Plugging effect of open-toe pipe piles in sandy soil.

Discussion on Ko, J. and Jeong, S., 2015 [in Canadian Geotechnical Journal 52(5) 535-547]

Bengt H. Fellenius, Dr.Tech., P.Eng.

Fig. D1 Force vectors in static loading of an open-toe pipe pile with inside soil column

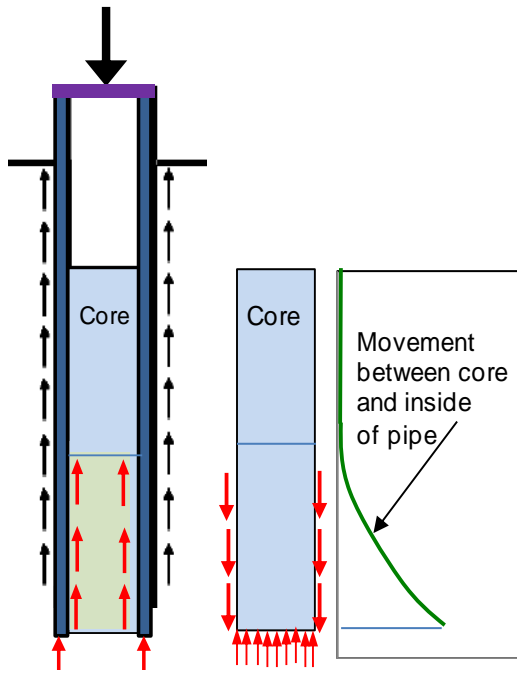
However, the response of the pile to a static force is very different to that shown in Figure 2 and is more similar to what I show in Figure D1. In static loading, the pipe is pressed down engaging shaft resistance along the outside and toe resistance on the annulus area, the relatively small area of the steel pipe wall. The inside column, the core, is made to follow the downward movement, but the movement meets resistance at the pile toe, which generates a base force that compresses the core and causes a relative movement between the inside wall and the core. That relative movement only acts along a distance represented by the length of the core compressed by the total base force, the length necessary to "spend the force" in a spring action with the compression of the core being equal to the toe movement.

Fig. D2 Pile 2. Load-movement curves for pile head and for gage depths at 1.9 m and 3.7 m for the outer and inner pipes, respectively

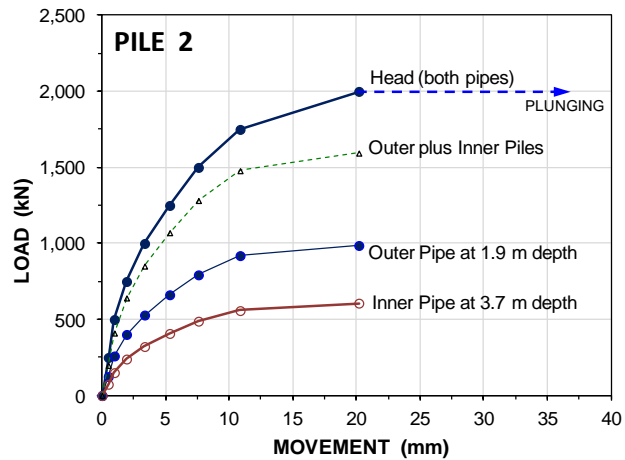
The actual load values determined in the static loading test reported by the authors are impaired because of the interaction between the outside and the inside pipes caused by the welding the pipe together at the lower end. This fact becomes obvious in Figure D2, which combines the authors' pile-head load-movement curves for Pile 2 (Figure 11) with the loads separated on the outside and inside pipes measured at depths of 1.9 m and 3.7 m, respectively (Figures 12a through 12f). The sum of the outer and inner pipes should be about equal to the applied load (curve labeled "Head both pipes"), but they are not. As can be expected from the response of the inner pipe, no change of resistance is likely to have developed between the pile head and the first gage level. In contrast, between the pile head and the first gage level in the outer pipe, an extrapolation indicates that up to 80 kN might have developed as shaft resistance along the outer pipe before the 1.9-m gage level. I believe the indicated about 400-kN difference between the sum of the outer and inner records of load and the 2,000-kN applied load is due to the interaction between the two pipes, as follows.

At the 2,000-kN maximum applied test load, Figures 12c and 12d indicate the loads measured at the first gage level in the inner and outer pipes were 610 and 990 kN, respectively. As the test arrangement theoretically ensured that the original equal length of the pipes was maintained, the imposed strain should be about equal for the two pipes (disregarding the shaft resistance acting along the outer pipe to the 1.9-m depth). Thus, the fact that the loads were converted from measured strain, means that the differences suggest that the cross section of the inside pipe would

be about two-thirds of the cross section of the outside pipe. Yet, it was actually about 10 % larger. Moreover, the tension loads reported for Pile 2 outside pipe (Figure 12d) were, in my opinion, caused by the unfortunate lower-end pipe connection. In its passage down the pile, the load applied to the outer pipe had to overcome shaft resistance, whereas the inside pipe met no resistance until encountering the effect of the core compression. Therefore, the total compression of the outer pipe was larger than that of the inner pipe. However, as the movement at the pipe ends (upper and bottom) were forced to stay equal, the result was that the compression measured at the lower strain gage level in the inner pipe increased by the amount necessary to suit the common length, the outer pile forced the inner pipe to compress. Either the sealing of the "gap" between the pipes should have been arranged to allow the outer pipe to slide past the inside pipe with no possibility of transferring force between the pipes, or the inner pipe should have been free at the upper end so that all applied load would have gone to the outer pipe. (While a disconnect at the lower end would have made for more reliable static load measurements, I realize that the dynamic test would then have become more complicated).

Fig. D3 Load distribution in a 7 m long open-toe, double-wall pipe pile (Paik et al. 2003)

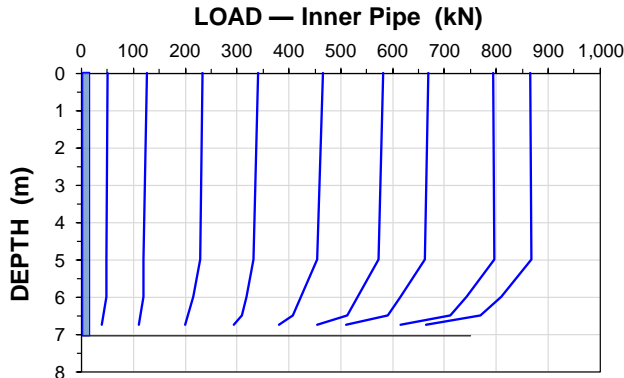
Figure D3 shows the distribution of load in the inner pipe confirming that the conclusion from the test by Paik et al. (2003) as to the shaft resistance along the soil core inside an open-toe pipe-pile only develops along a short distance up from the pile toe. For this test, the seal of the "gap" between the two pipes was made with a silicon compound that allowed the two pipes to slide past each other. Moreover, the test was arranged with strain-gages measuring the load applied to each pipe at the pile head separately at the ground surface, the sum of the loads in each pipe was equal to the total load applied.

Fig. D4A Simulated test on the pipe pile, open-toe

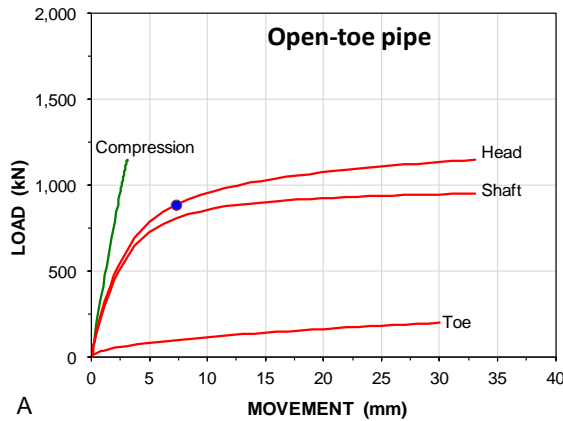
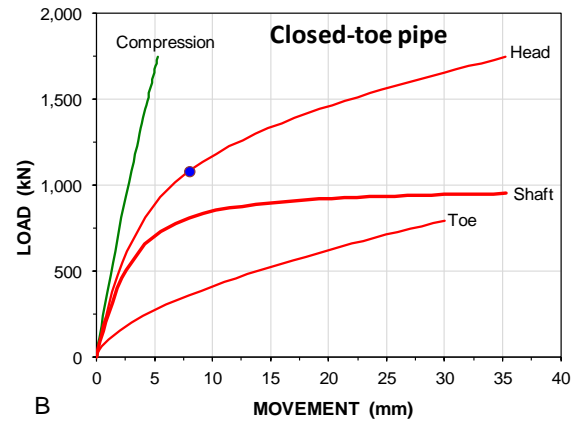
Figure D4 shows a simulations of the response to static loading of two pipe piles, one open-toe and one closed-toe, of dimensions similar to the outer pile of the authors' Pile 2 (OD 711 mm, wall 7 mm, and length 11m) driven into a sand similar to that of the case history. The simulation is made using the UniPile software (Goudreault and Fellenius 2013) using an average beta-coefficient of 0.40 and a toe resistance of 2 MPa. The shaft response is described by a hyperbolic function with the 0.40 beta-coefficient shaft resistance mobilized at a relative movement of 5 mm between the shaft and the soil. The toe resistance is described by a ratio function with an exponent of 0.600 and the 2 MPa toe-resistance mobilized at 30-mm toe movement (Fellenius 2014).

For the simulated load-movement curves for the pile driven open-toe, I have assumed that after the driving, a soil core exists inside the full length of the pipe. The outer shaft resistance is the same as that for the closed-toe case. Moreover, I have assumed that the shear force between the core and the pipe has been activated along a 2.5 m length, that the average shear force is 40 kPa, and that the core has an E -modulus of 50 MPa. This establishes that, for a toe movement of 30 mm, the toe force is about 200 kN. With a bit of allowance for the force on the steel wall (the 7-mm annulus of the pile; the steel cross section), this is the toe resistance of the open-toe pile at that toe movement.

the pile driven closed-toe as opposed to that driven open-toe. A useful relation in practice is the load at the pile head that results in a certain pile toe movement. The circles in Figures D4A and D4B indicate the pile head load for a 5 mm toe movement, which is usually a safe value of "allowable load". It includes an allowance for group effects that can increase the toe movement during long-term service, and, therefore, the pile foundation settlement, as well as for moderate amount of future downdrag. Note that although the difference in toe resistance at the large toe movement (30 mm) between the closed- and open-toe pipes is about 600 kN, at the more moderate 5 mm toe movement, the difference is only 200 kN.
